Technical Bulletin

TB5000-065

5000 Bodymaker

Dual Air Strip Valve

New Dual Air Strip Valve Assembly

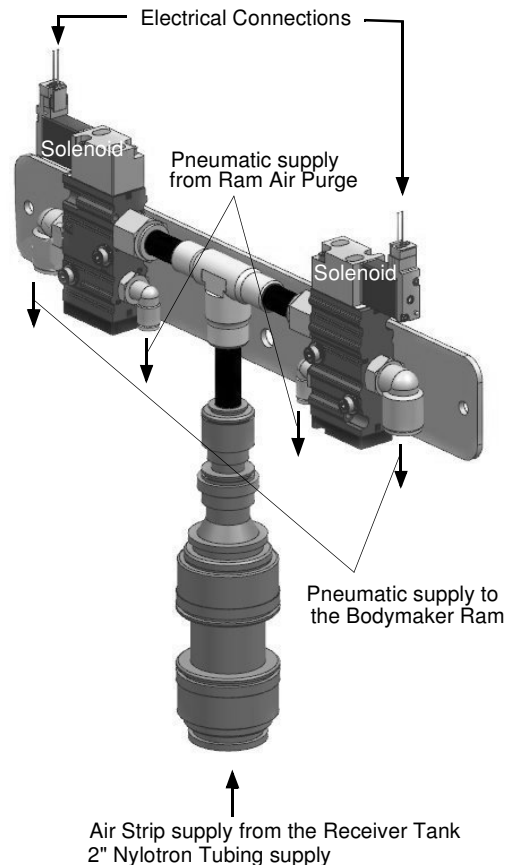
CarnaudMetalbox now have available a design up-grade for their Air Strip Valve arrangement offering customers the following benefits:-

The Air Strip Valves can operate alternately or on their own, therefore allowing failed valves to be changed without stopping production.

Doubling the amount of valves halves the duty cycle of each valve, therefore allowing a longer planned maintenance period.

Fitted as standard on all new Bodymakers (from serial number 831s) this Dual Air Strip Valve Arrangement is also available as an upgrade kit for earlier machines.

The Dual Air-Strip valve fits directly in place of the existing Air -Strip valve of your 5000Mk2 Bodymaker. Refer to the illustration for the relevant connections.
